<b>Docket Number:</b>	17-BSTD-02
<b>Project Title:</b>	2019 Title 24, Part 6, Building Energy Efficiency Standards Rulemaking
<b>TN #:</b>	224203
<b>Document Title:</b>	Jeff Sutton Comments Fenestration Shading Devices
<b>Description:</b>	N/A
<b>Filer:</b>	System
<b>Organization:</b>	Jeff Sutton
<b>Submitter Role:</b>	Public
<b>Submission Date:</b>	7/18/2018 5:47:00 PM
<b>Docketed Date:</b>	7/18/2018

## **Fenestration Shading Devices**

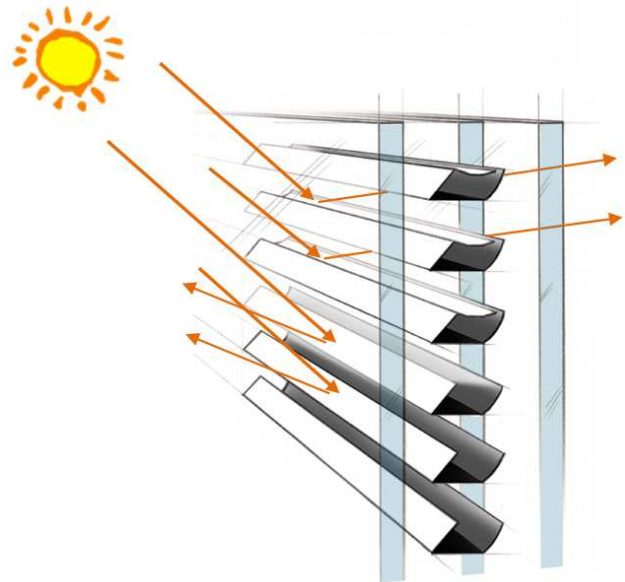
It is not clear from the text that a fixed shading screen such as the Okalux internal fixed louver would be treated as an external shading device. As it is between the glazing, it seems like it could be interpreted as "blinds", and "Glazing systems that use blinds between the glazing layers are also considered internal shading devices", and "Internal shading shall not be modeled in the proposed design, unless it is automatically controlled". This comment was intended to address Pella type windows with the internal mini-blinds that can be adjusted manually. These louvers are fixed, and should be correctly noted to be treated as an exterior shading device - otherwise this type of product and many others like it will not be utilized if the benefits can not be modelled.
